Kingsway Solar

Targeted consultation

7 January – 4 February 2026

Change 1: Solar panels in Development Area A – west

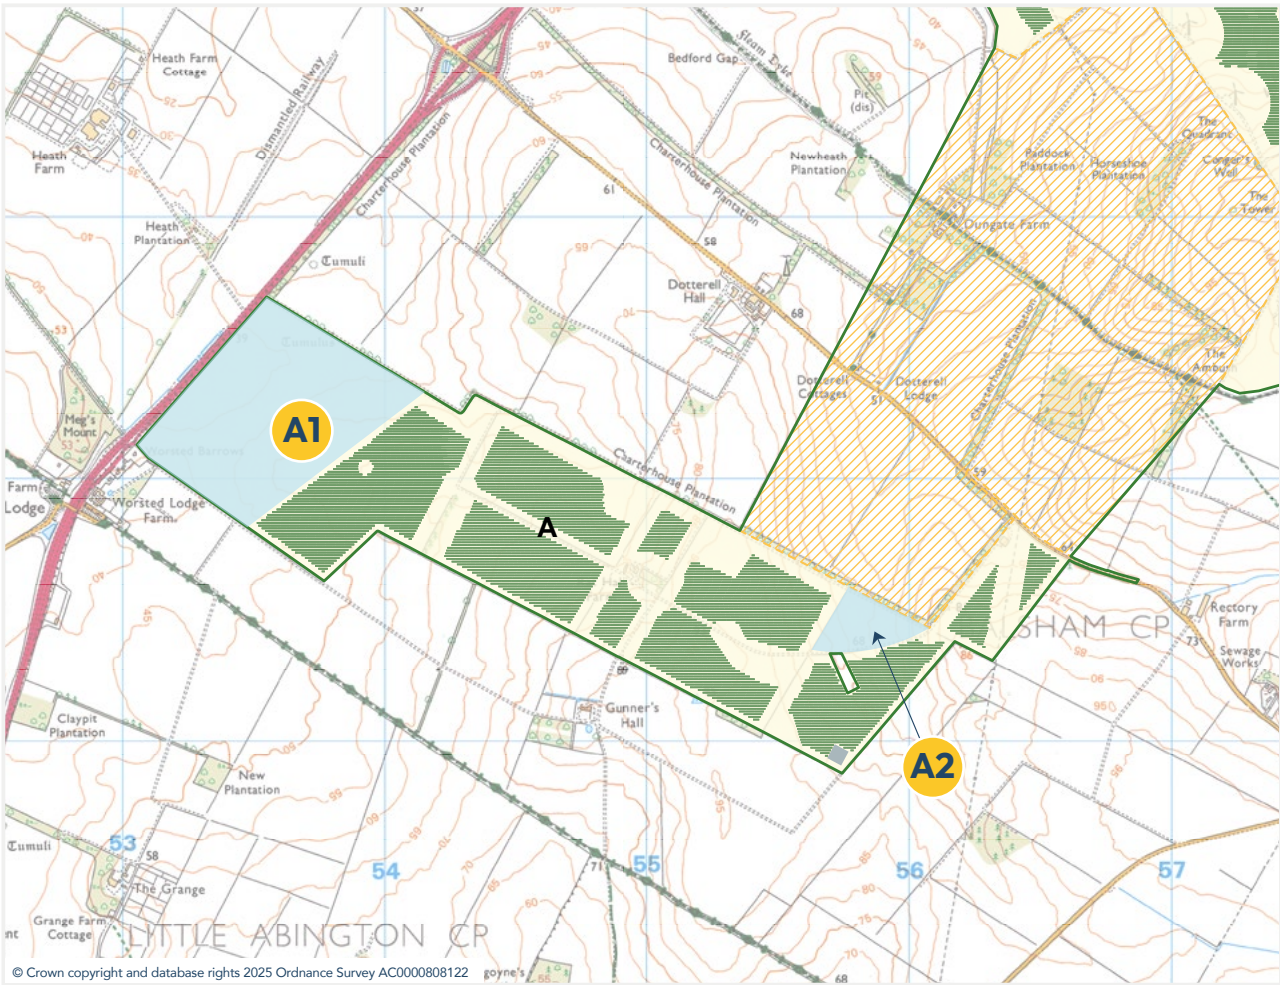
- A1** The field closest to the A11 is proposed as a new location for solar panels because of its size and limited constraints. Archaeological constraints in this field will be considered in preparing the detailed layout.
- A2** While this field comprises some Grade 2 agricultural land, it would not have been made available for continued agricultural use during the operational phase under the previous design and so has been included within the layout for panels.

Change 2: Solar panels in Development Area B – central

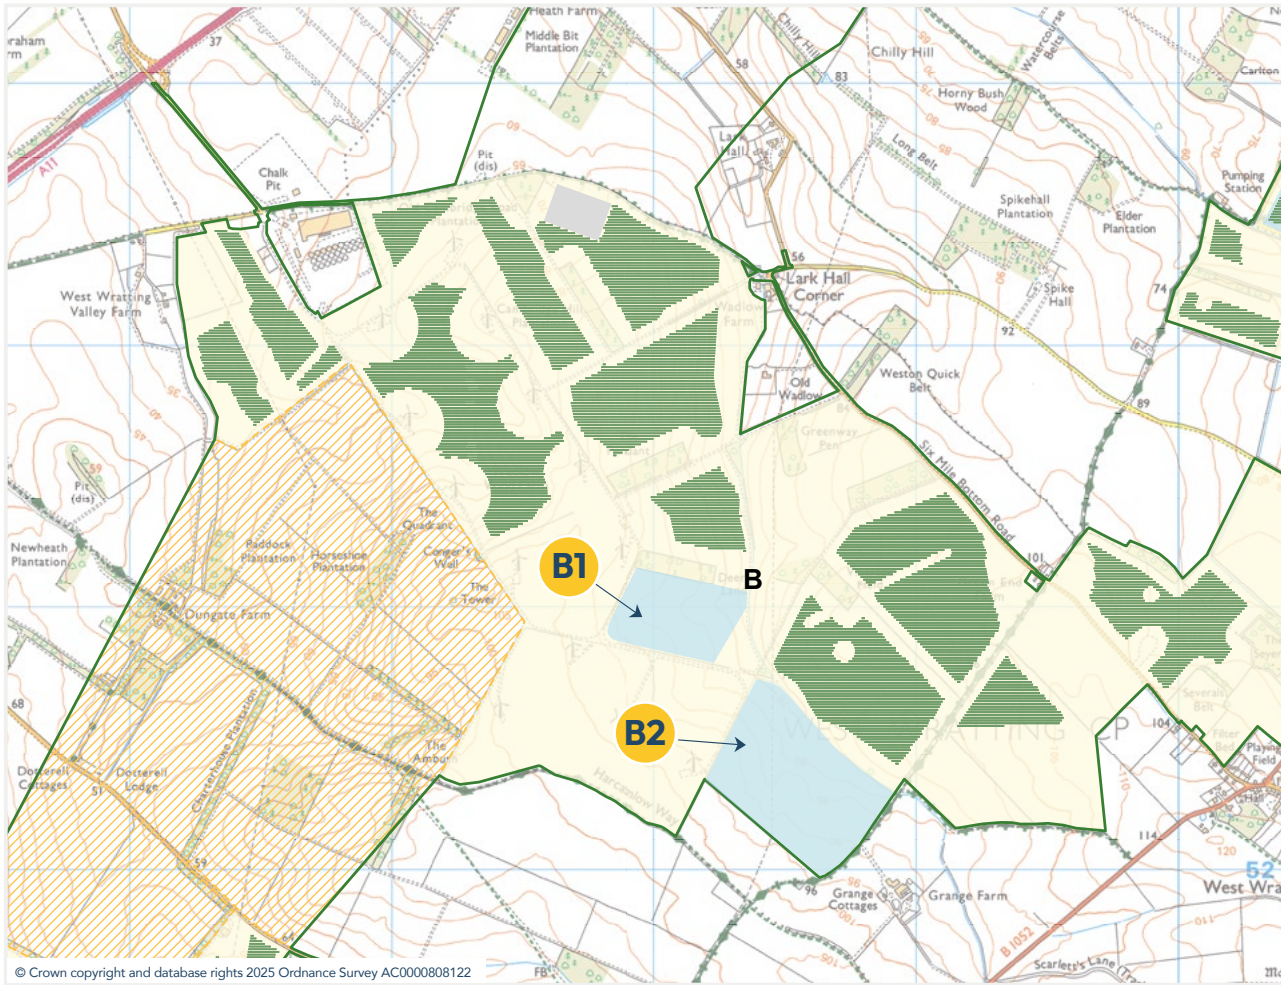
- B1** This field is proposed as a new location for solar panels because of its size and limited constraints.
- B2** This field is proposed as a new location for solar panels because of its size and limited constraints.

Land continues to be set aside within the southern extent of Development Area B for potential landscape and ecological mitigation.

Change 3: Solar panels in Development Area C – east

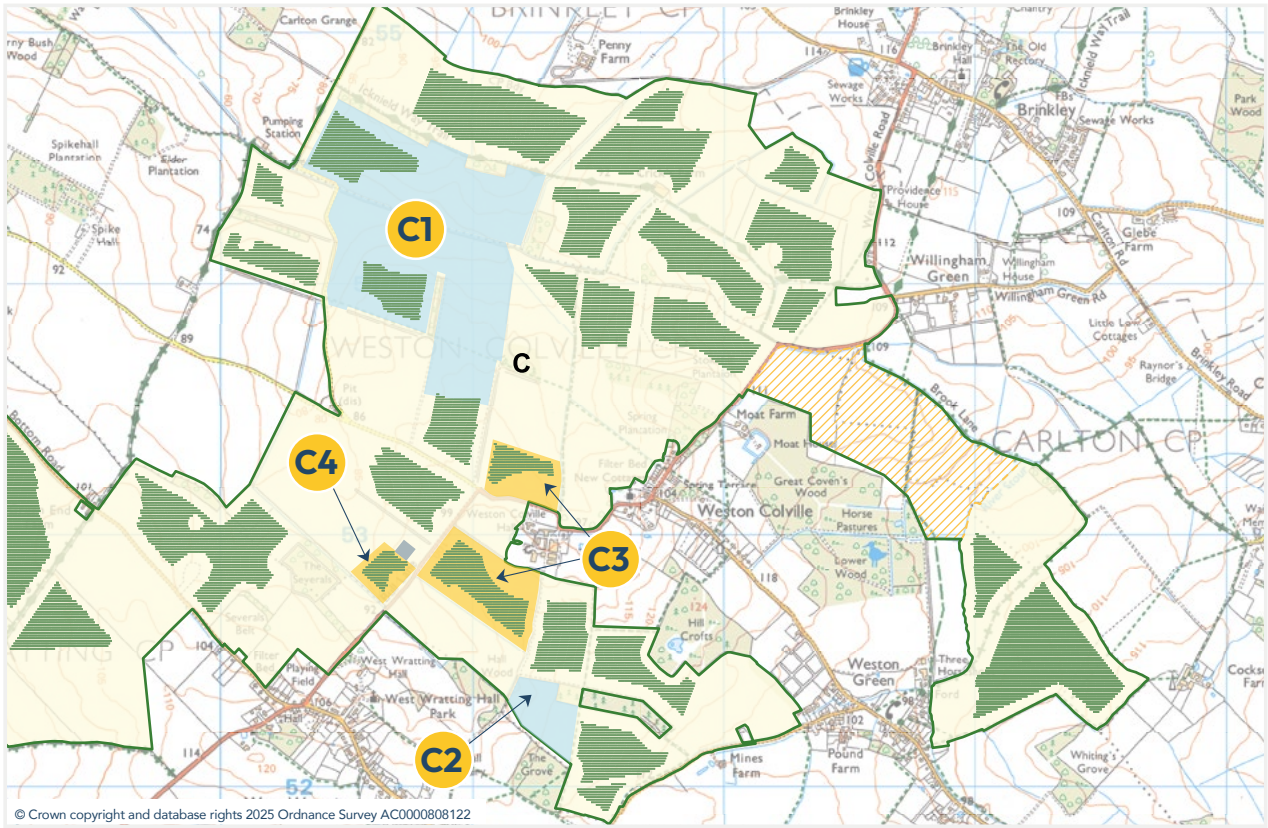
- C1** These fields are proposed as new locations for solar panels because they are central to Development Area C, consolidating previously proposed solar panel field locations with separation from residential areas.

- C2** The field is proposed as a new location for solar panels because of its distance from residential areas and its limited constraints. The proximity of the new fields (C1 and C2) to public rights of way will be considered in the landscape enhancement strategy.

- C3** These fields are identified to be removed from the solar panel layout in response to feedback received during the stage two consultation on the potential impact to the setting of listed buildings, including Hall Farm and St Mary's Church in Weston Colville.

- C4** This field is identified to be removed from the solar panel layout to accommodate the substation in Development Area C, including access and drainage areas.

Change 5: Development Area B – 400kV on-site substation and BESS compound

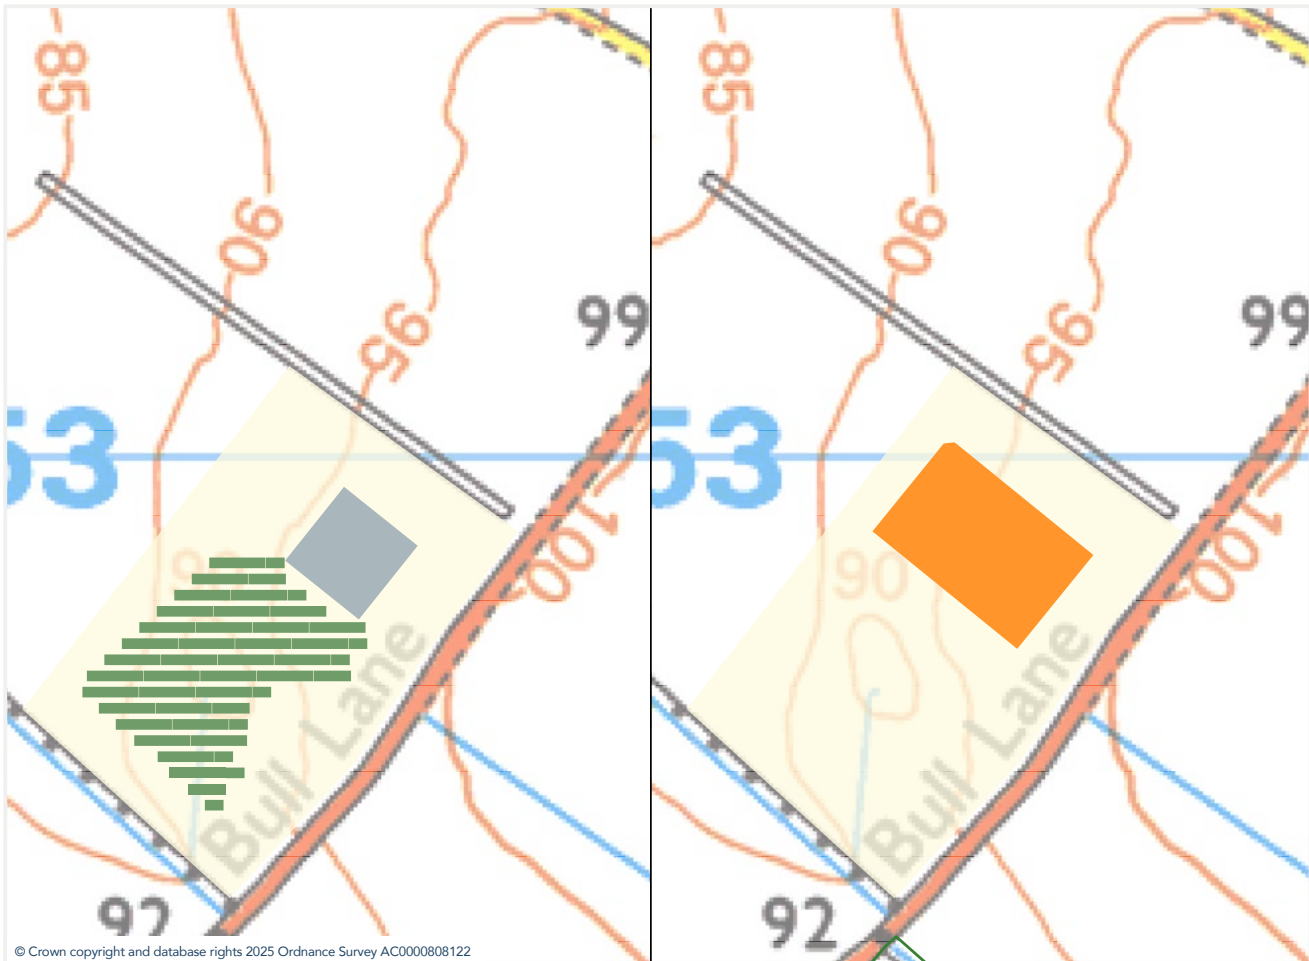
Following further detailed engineering design work, the size of the 400kV on-site substation and BESS compound in Development Area B has been increased compared to the plans shown during the stage two consultation. The additional land is required to accommodate the electrical equipment needed within the compound, as well as maintenance and emergency accesses, fire safety equipment and water retention systems.

The increased area of the substation and BESS compound remains within a field also presented during the stage two consultation to contain solar panels, and the solar panels will be reduced in extent to accommodate the change. No increased effects for this change are anticipated compared to those identified in the PEIR.
